**EIA Report on
Lok Ma Chau Loop**

**Further information from project proponent in response to
comments/queries raised by Members of ACE EIA Subcommittee
at the meeting on 19 August 2013**

Civil Engineering and Development Department
September 2013

Figure 1 – Emergency exit route 1 without the ECR

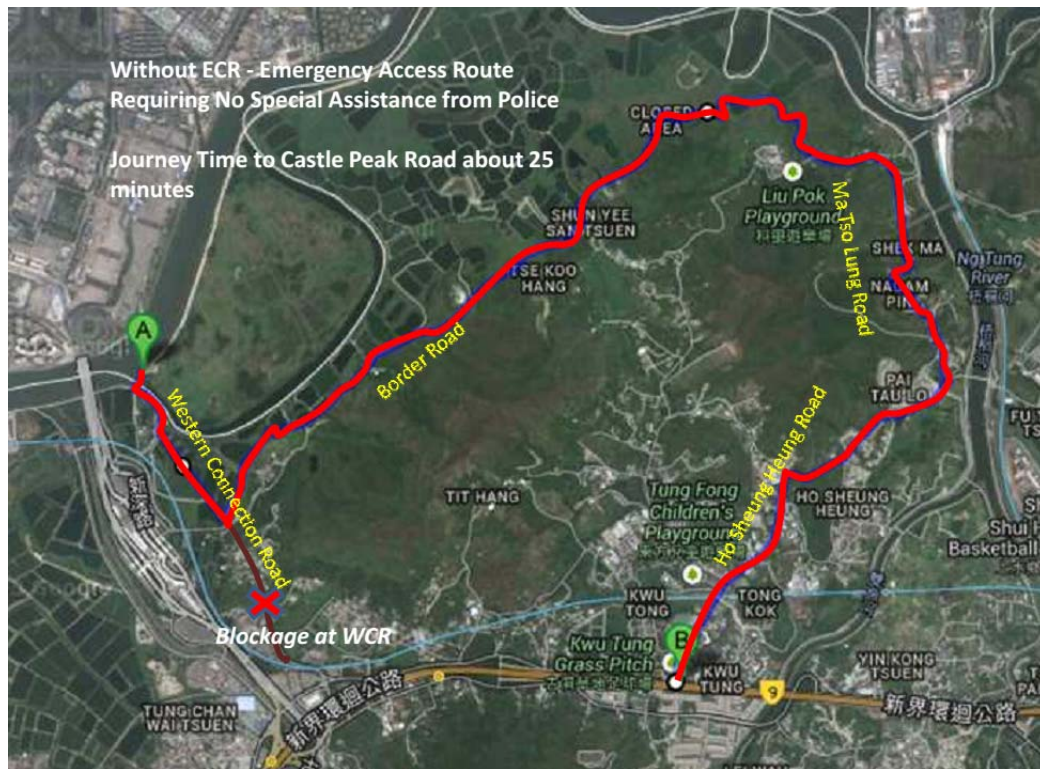
- (a) submit further information to respond to/clarify Members' comments/queries on the following 3 major issues deliberated at the ACE EIA Subcommittee meeting on 19 August 2013:
 - i. Eastern Connection Road;
 - ii. Integrating some reed beds into the Amenity/Activity Corridor; and
 - iii. Urban design considerations; and
- (b) invite Members to reconsider the captioned EIA report at the forthcoming ACE EIA Subcommittee meeting on 13 September 2013.

- 2.3 From the emergency/incident management angle, alternative access to a community with total of over 50,000 student/employee population when fully developed should be a valid justification. As one end of the Direct Link is only linking to the MTR LMC Station/LMC Spurline Boundary Control Point (BCP), the Direct Link is not

an external connection road. Should the Western Connection Road (WCR) fail, it will take longer travelling time and distance for emergency vehicles to reach the LMC Loop via the existing old and narrow Border Road (single lane two-way) and Ma Tso Lung Road (single lane two-way) from Fanling Highway. Even if the near- LMC- Loop section of the WCR is still functional, accessing the LMC Loop from the west of the WCR via the Border Road near the MTR LMC Station/LMC Spurline BCP will still be subject to similar constraints above. Figures 1 and 2 show the emergency routes without the proposed ECR.
